**RE: WESTLAKE CITY LANDFILL
CUYAHOGA COUNTY
GROUND WATER
NOTICE OF VIOLATION
ADDITIONAL INFORMATION NEEDED**

The Ohio Environmental Protection Agency (Ohio EPA), Northeast District Office (NEDO), has reviewed the following report for Westlake Landfill:

- Semi-annual Assessment Activities Report, dated July 16, 2012.

Purge Drawdown - WW2

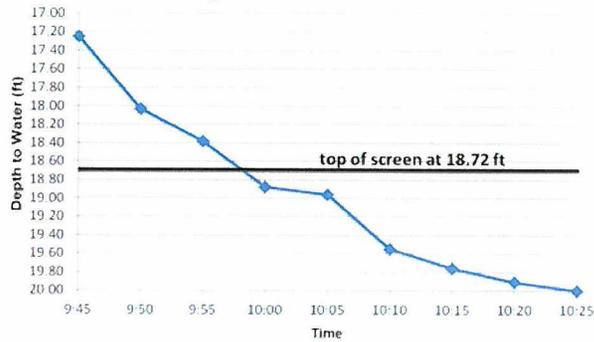
Graphical displays of drawdown at select monitoring wells that did not achieve a stabilized drawdown (WW-2, WW-10, WW-11, WW-12) are shown in "Purge Drawdown" below. Additionally, for reference, drawdown at select monitoring wells that did achieve a stabilized drawdown (WW-4, WW-5) are also shown in "Purge Drawdown" below. Specific provisions in the SAP that were not followed include the following:

- The water level in monitoring wells WW-2 and WW-10 was drawn down below the top of screen during purging and sampling. The SAP states that “If the static water level is above the well screen, the water level should not be allowed to fall below the top of the screen. To minimize disturbance, pumping rate adjustments are best made within the first fifteen minutes of purging.” As shown on the drawdown graphs for WW-2 and WW-10 below, drawdown dropped below the top of the well screen about 15 minutes into purging at WW-2 and about 10 minutes into purging at WW-10. The pumping rate should have been lowered prior to the water level dropping below the top of screen such that drawdown would stabilize above the top of the well screen.

- Purge stabilization measurements and the ground water samples at WW-2, WW-10, WW-11 and WW-12 were obtained prior to drawdown stabilization. The SAP states “stabilization measurements should begin after drawdown of the water level has stabilized,” and “a sample can be considered representative when both drawdown and water quality indicators have stabilized,” and “the stabilization should be documented.” However, as documented among the June 2012 drawdown data from monitoring well sampling data forms for WW-2, WW-10, WW-11 and WW-12 and as shown on the graphs below, drawdown was not stabilized at WW-2, WW-10, WW-11 and WW-12 at any time prior to collection of stabilization parameter measurements or prior to sampling. The owner or operator should have lowered the pumping rate and stabilized the drawdown prior to collection of stabilization parameter measurements and sampling should have been delayed until both drawdown stabilization and subsequent stabilization of parameters was achieved across three consecutive measurements.

To demonstrate compliance at future sampling events, the owner or operator must comply with the low-flow purging and sampling procedures described in the SAP, including as specified in the bulleted paragraphs above.
